TO: Joe Helfrich, Inspection and Enforcement Supervisor *JH*
FROM: Wayne H. Western, Senior Reclamation Specialist *WHW*
RE: Amendment, Conveyor Replacement, White Oak Mining and Construction Co., Inc., White Oak Mine #1 and #2/Loadout, Folder #2, ACT/007/001

SYNOPSIS

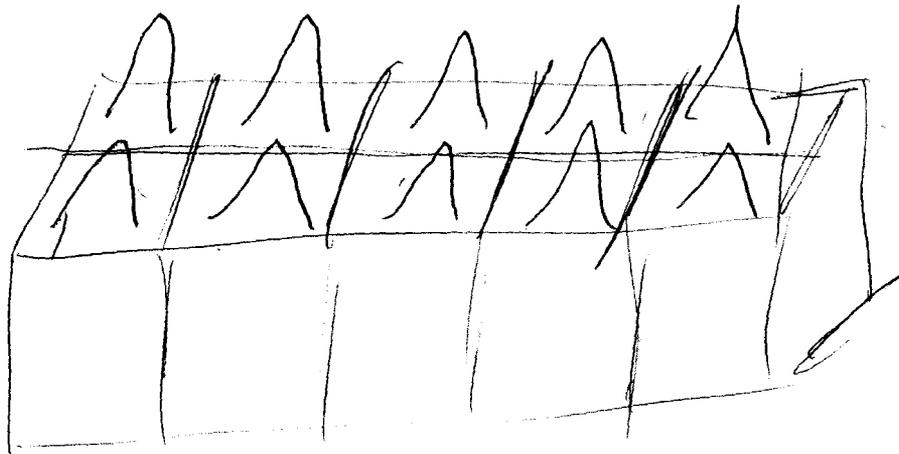
The amendment did not include a cross section of the drains or indicates what the slope of the pipes would be. A cross section should be included in the amendment so that the Division can determine if the pipes will be installed correctly.

The Division wants to know the slope of the pipes. If the slope is too, gentle flows could be restricted. Should the slope be too great then the flow velocity could cause piping. The Division requests that the slope of the pipes be between ½ percent and 2 percent.

Deny the sediment area drain because the Operator failed to meet the conditions of R645-301-535.130 by not demonstrating that the drainage system is compatible with the surrounding conditions. The Operator needs to state what the slope of the pipes will be and provide the Division with a cross section showing the pipes.cc:
